**Economic Commission for Europe****Inland Transport Committee****World Forum for Harmonization of Vehicle Regulations****Working Party on Passive Safety****Sixtieth session**

**Regulation No. 129 (Enhanced Child Restraint Systems)****Proposal for Supplement 1 to the 02 series of amendments to Regulation No. 129****Submitted by the expert from France\***

Figure 1

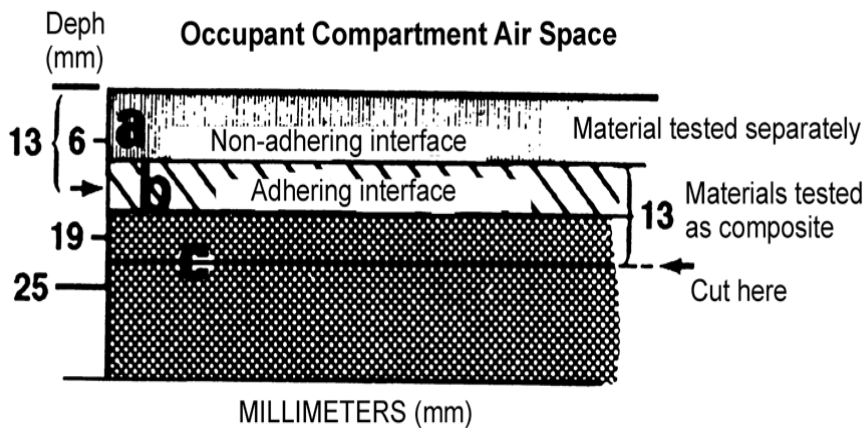
- 2.1. Any portion of a single or composite material which is within 13 mm of the occupant compartment air space shall meet the requirements in Paragraph 6.1.6.
  - 2.1.1. Any material that does not adhere to other material(s) at every point of contact shall meet the requirements of paragraph 6.1.6. when tested separately
  - 2.1.2. Any material that adheres to other materials at every point of contact shall meet the requirements of paragraph 6.1.6. when tested as a composite with the other material(s).
- Material A has a non-adhering interface with material B and is tested separately.
- Part of material B is within 13 mm of the occupant compartment air space, and materials B and C adhere at every point of contact; therefore, B and C are tested as a composite.
- The cut is in material C as shown in Figure 1, to make a specimen 13 mm thick.
